DEVELOPMENT REVIEW BOARD
SUPPLEMENTAL SUBMITTAL

PROJECT NO. 2022-006547

Application No. SI-2022-00216

RE: Panda Express – S8-22-D8582
10126 Coors Blvd. NW
Albuquerque, NM 87114
RE: DRB Planning Review – 1st Resubmittal
DRB Project Number: 2022-006547
App. Number: SI-2022-00216

SITE PLAN

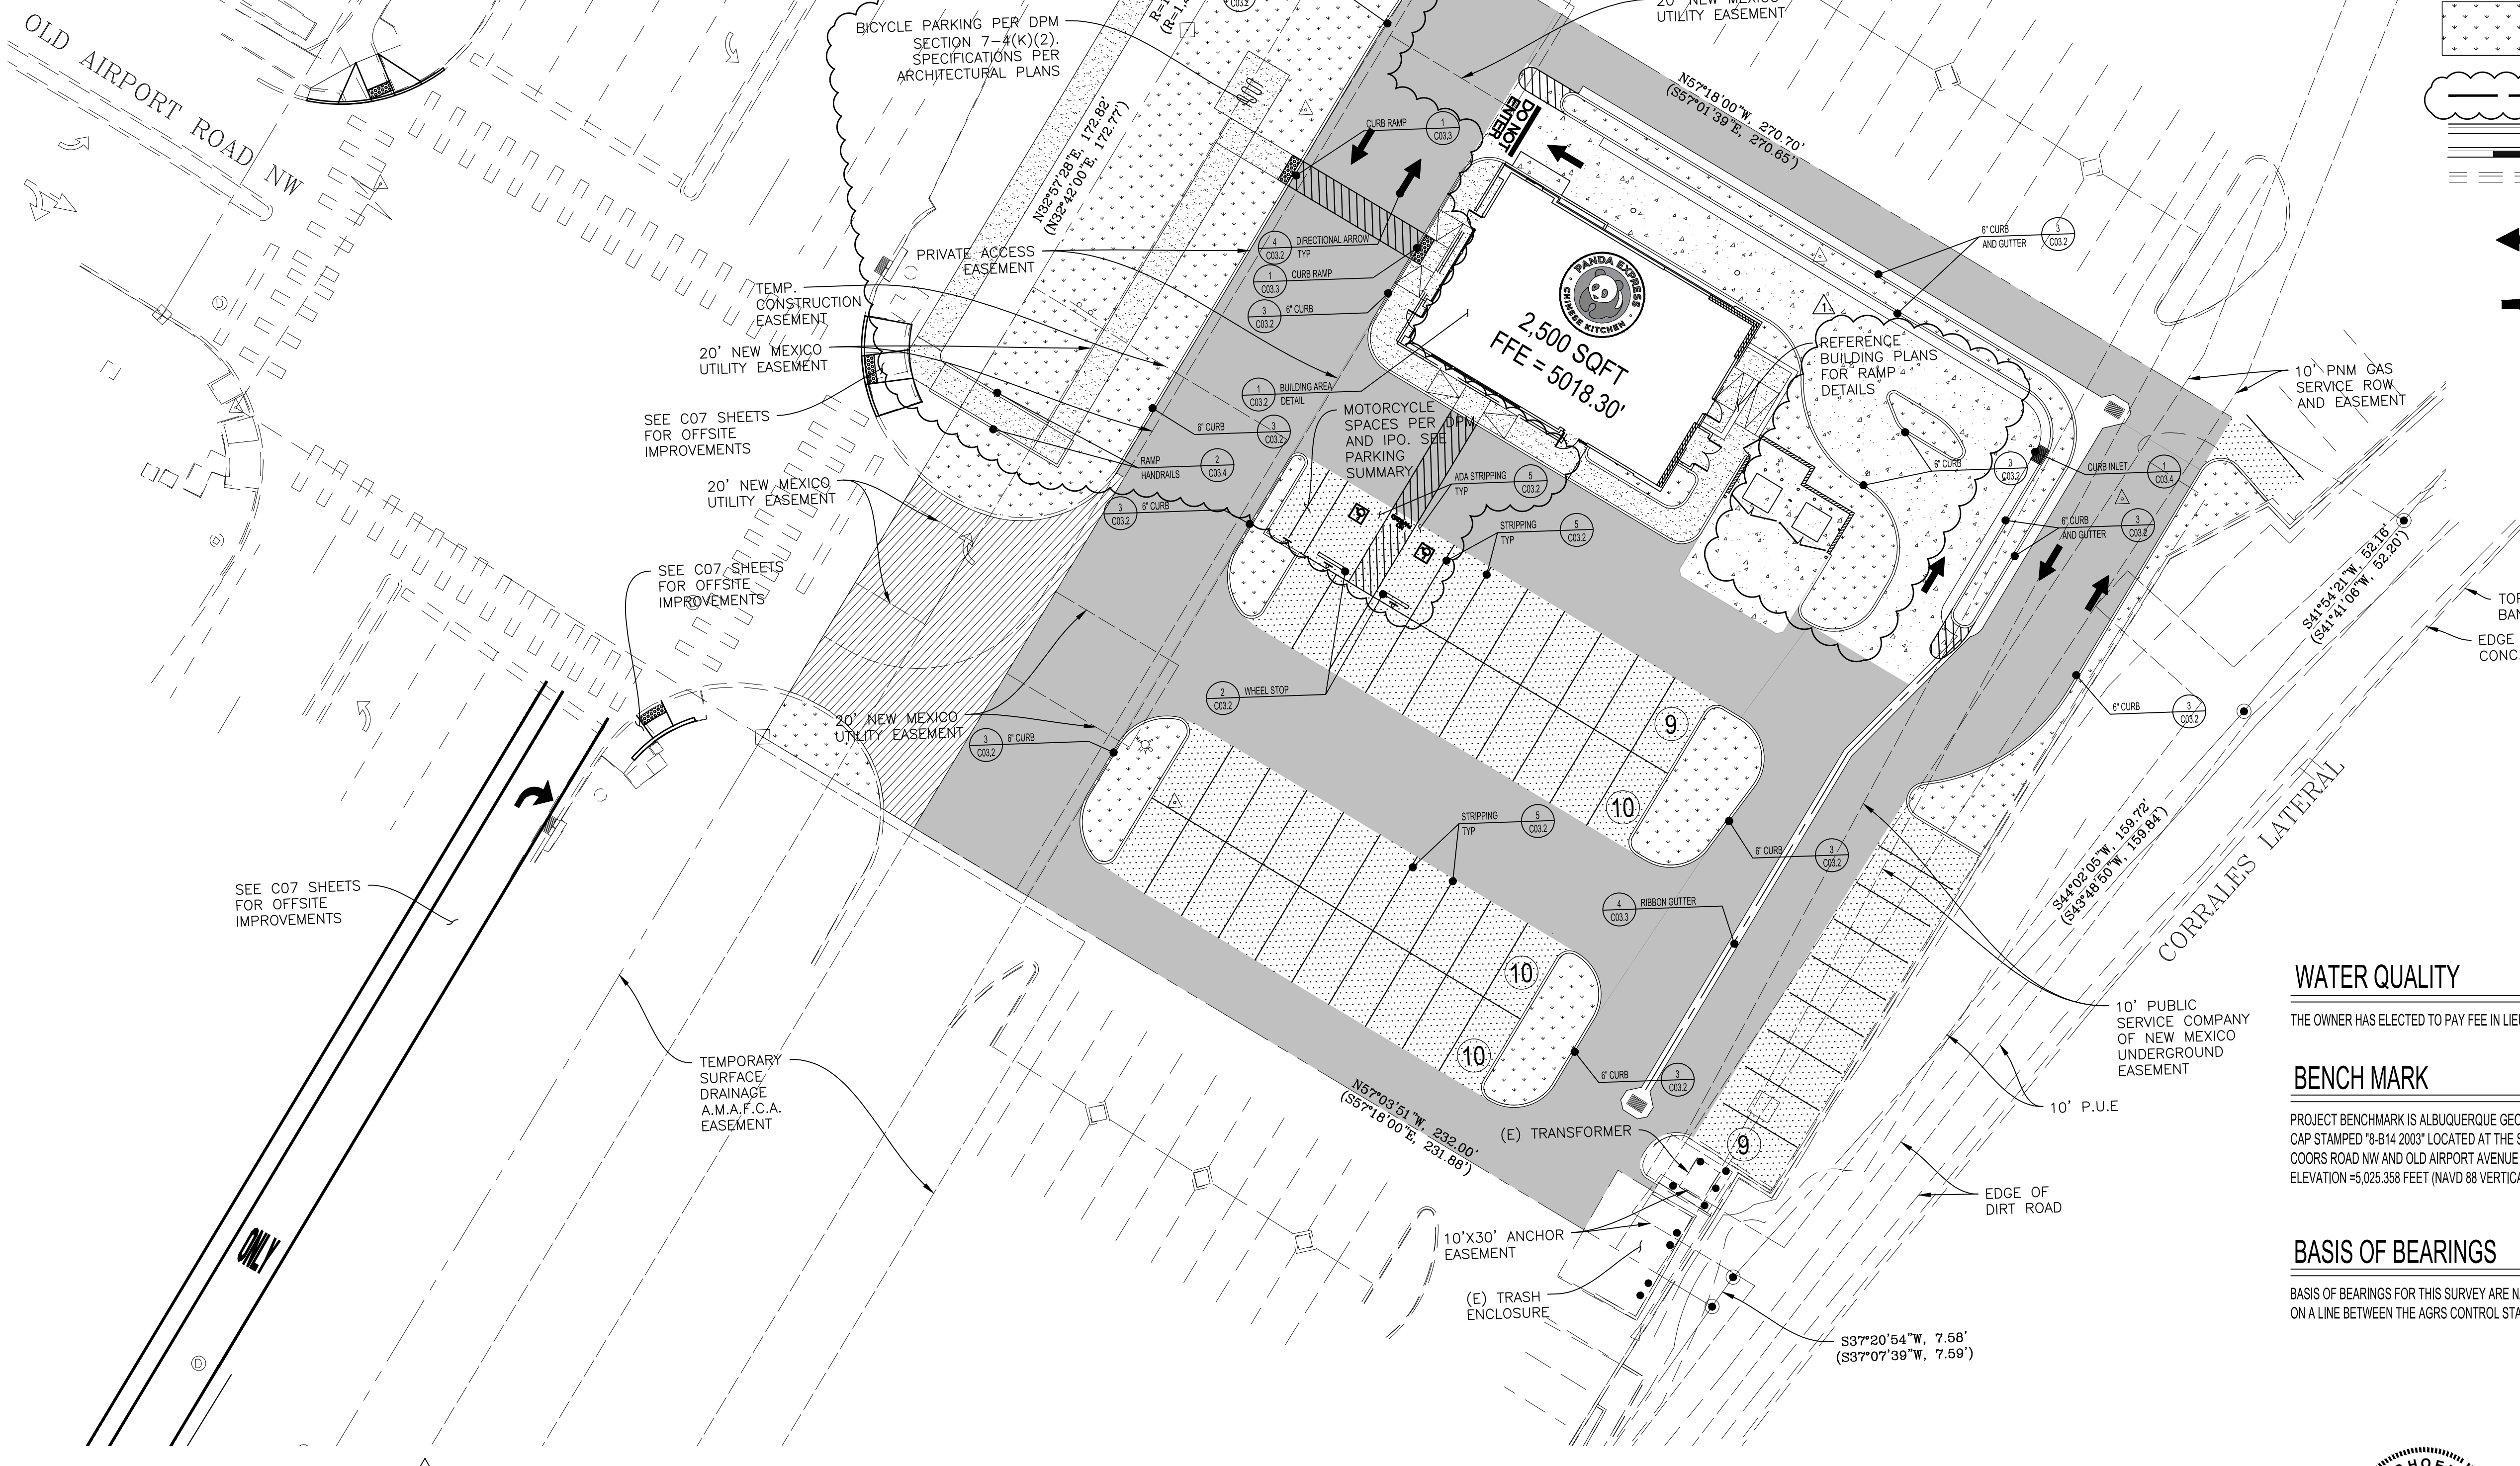
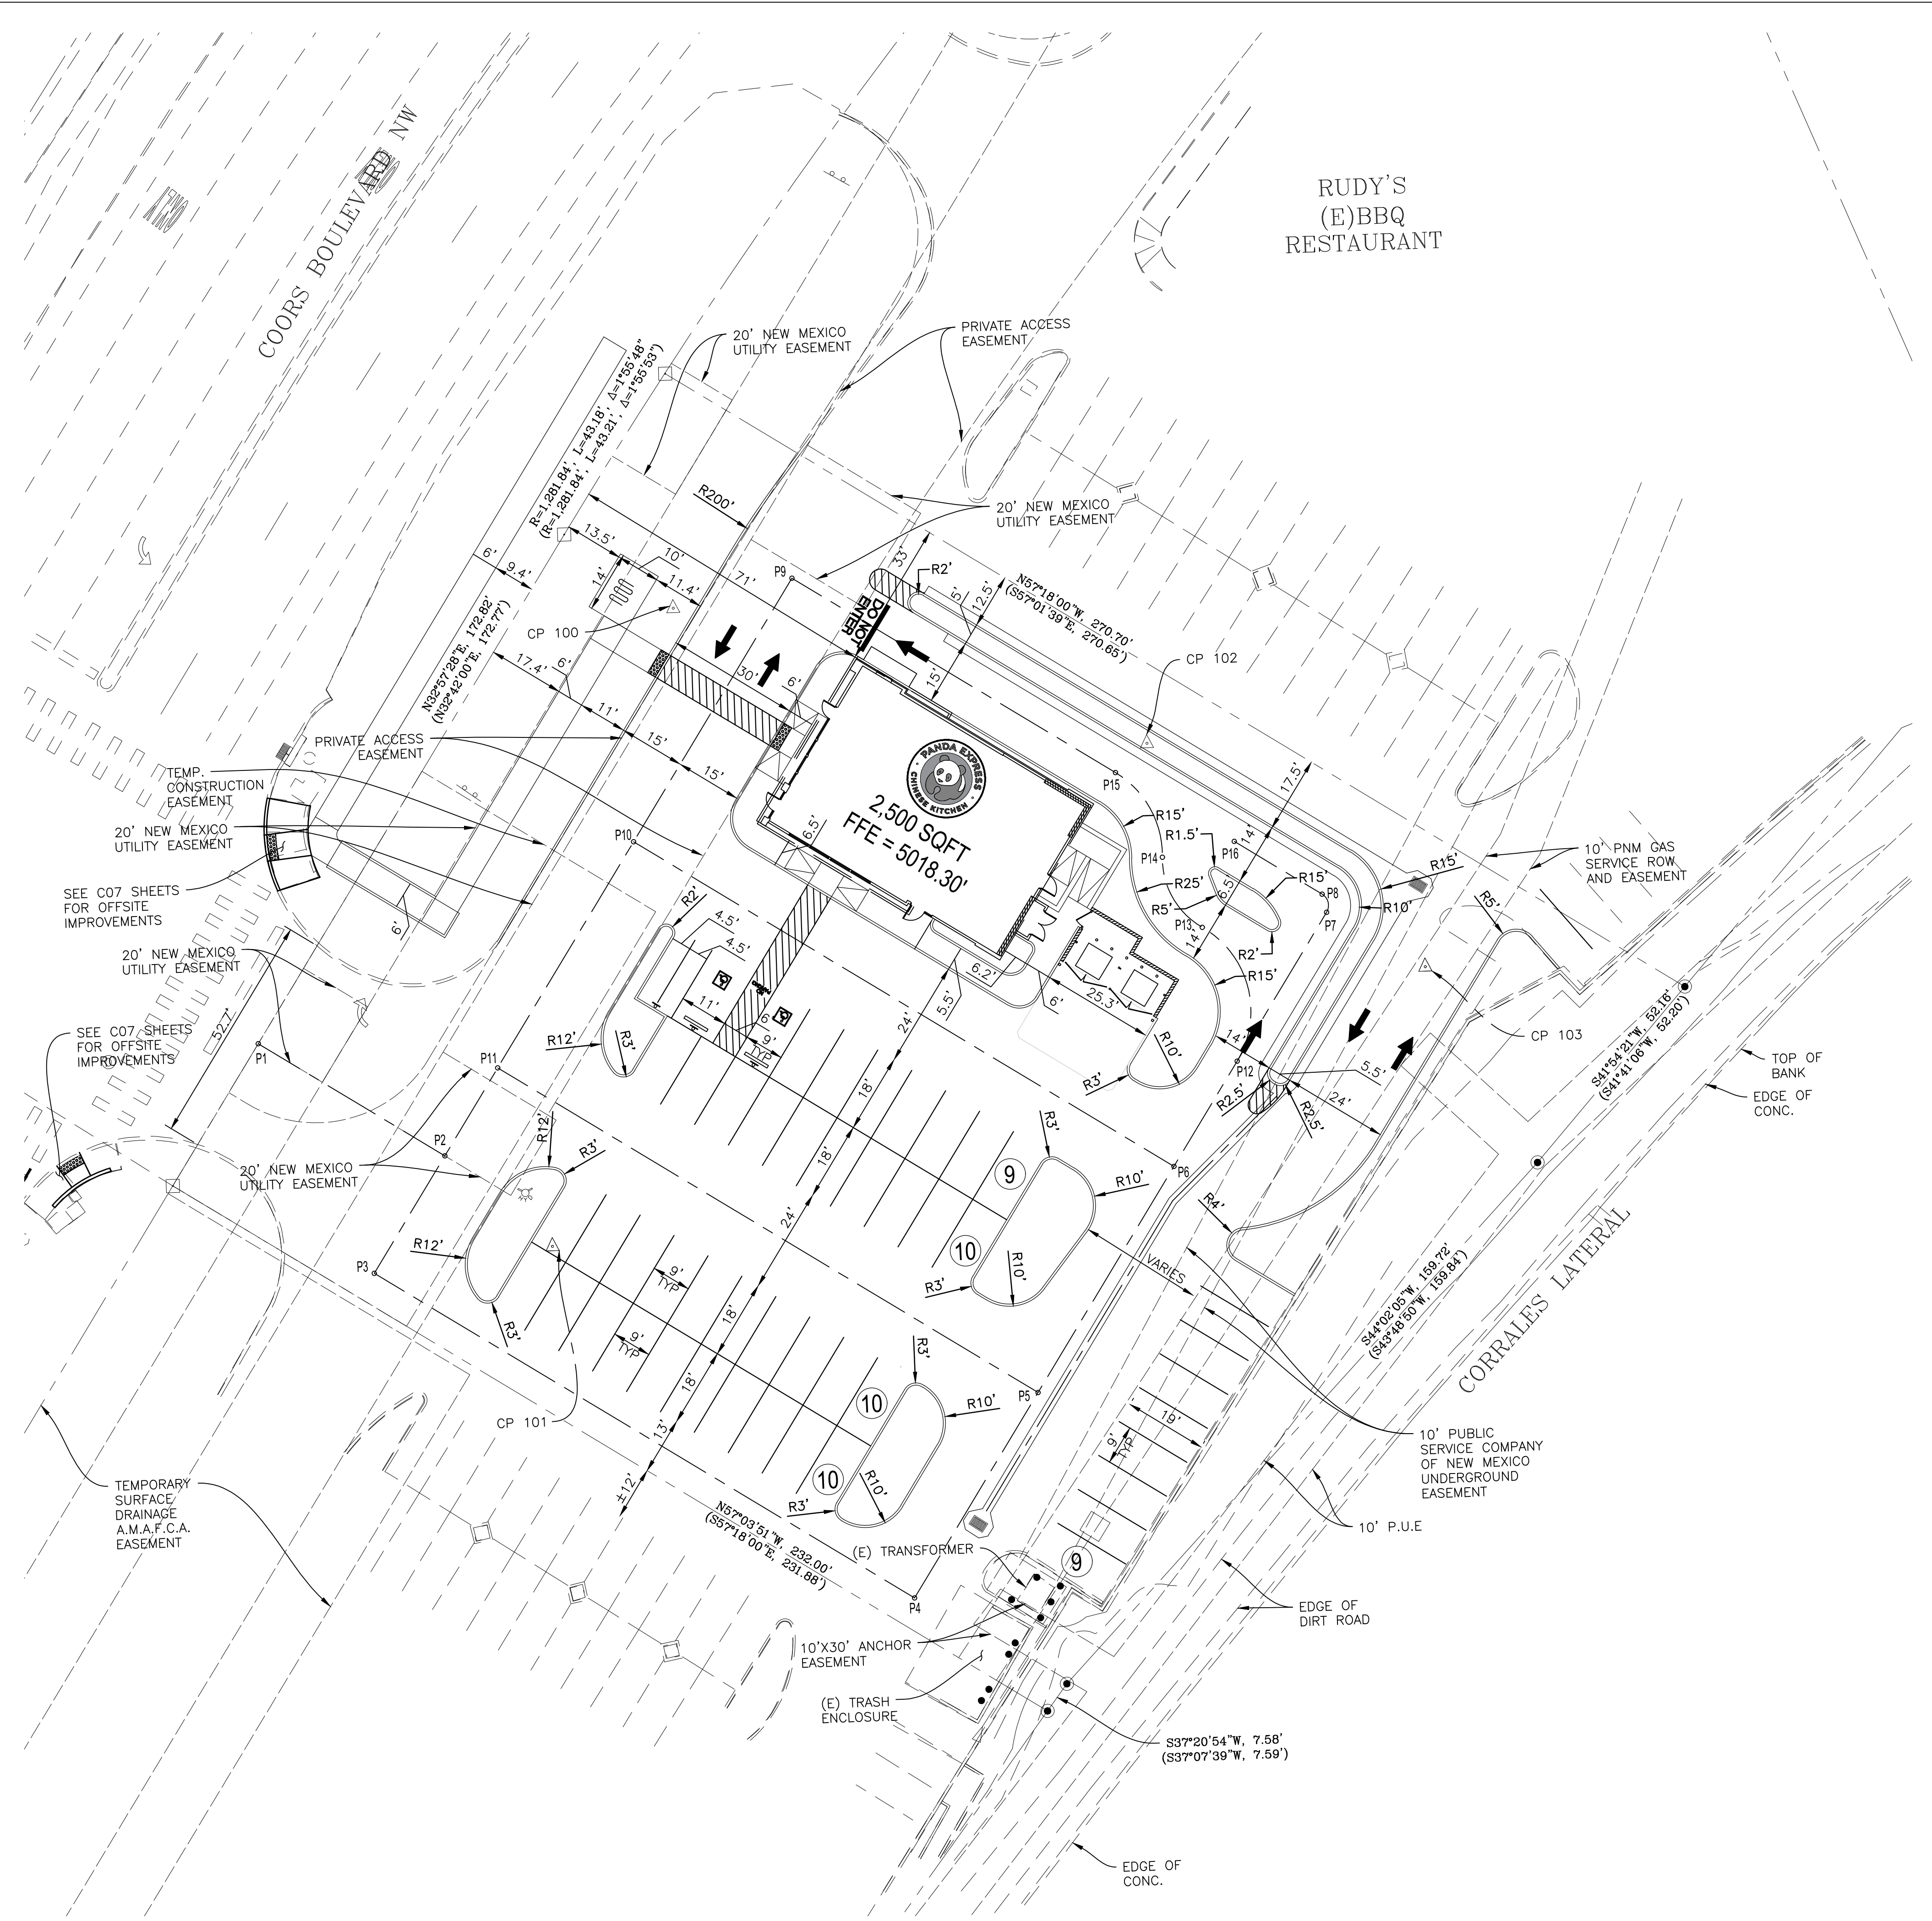
6. Provide sidewalk, curb, and curb ramp details. Reference correct curb ramp details with keyed notes on the site plan.

7. For the drive-thru, one-way, "Do Not Enter" signage, and pavement arrows shall be called out on the site plan.

Response: Refer to detail sheets C03.0, C03.3 and C03.4 for detail information.

Response: Refer to sheet C03.0 Site Plan and A-100 Site plan for the location of the "Do not enter" signage and directional arrows.
